WASH-1520

ENVIRONMENTAL STATEMENT

CONTAMINATED SOIL REMOVAL FACILITY

UNITED STATES ATOMIC ENERGY COMMISSION

FIGURE 3
200 WEST AREA MAP

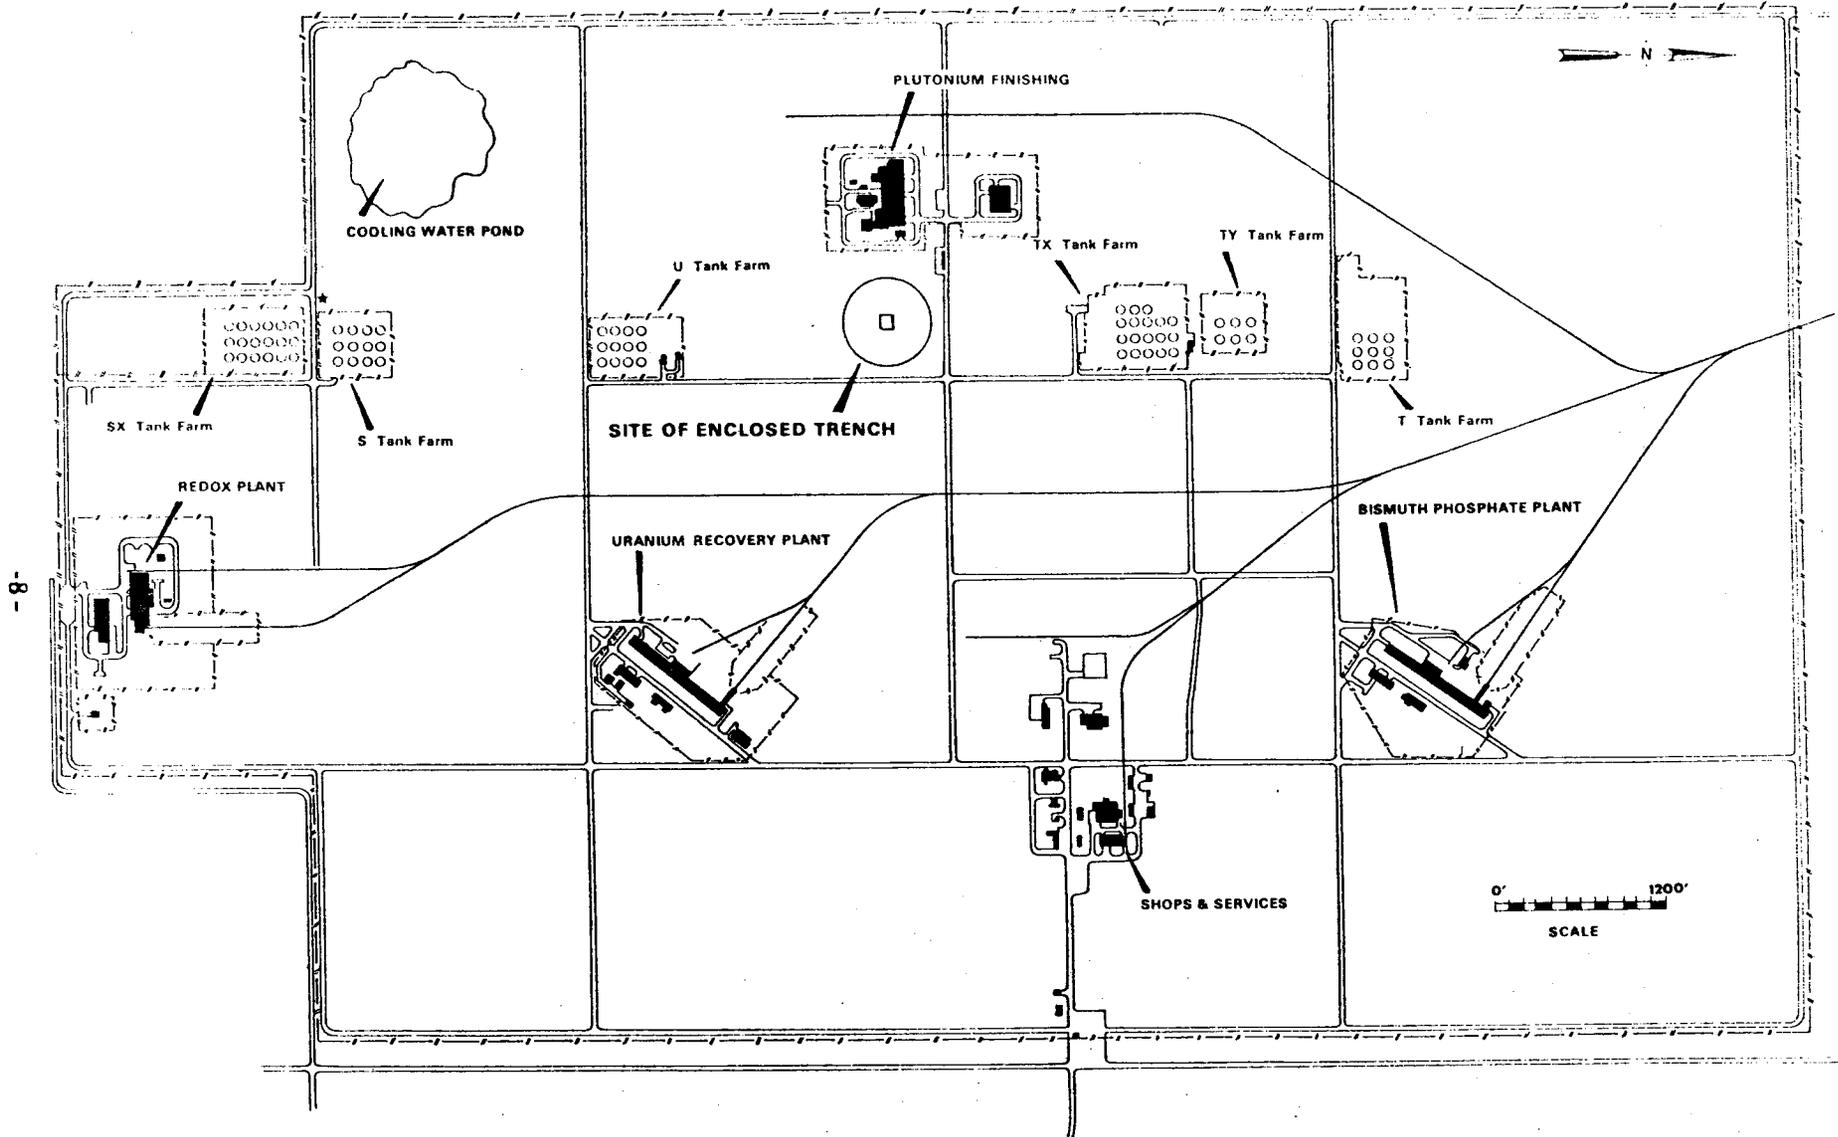
Comment: "From the description of the facility operation we have concluded that the only release of radioactivity to the atmosphere is via vents from the Contaminated Soil Removal Facility and the Underground Storage Facility (apparently called the Contaminated Soil Storage Vault in figure 8).

Neither facility is located on figure 3, but since the text states that they are within 250 feet of the Plutonium Finishing Plant, we have estimated a distance of 250 meters from the point of effluent release westward to the nearest fence surrounding the 200-W Restricted Area. We have assumed that the 200-W Restricted Area is considered controlled, while outside the fence is an uncontrolled area, access to which is not restricted for reasons of radiation safety."

Reply: Both the Contaminated Soil Removal Facility and Underground Storage Facility will be located within the circle marked "Site of Enclosed Trench" on figure 3. The entire Hanford Plant (as shown on figure 2) is considered a controlled area and concentrations given in the statement for releases to an uncontrolled area are calculated at the plant boundary approximately seven miles from the 200-W Area.
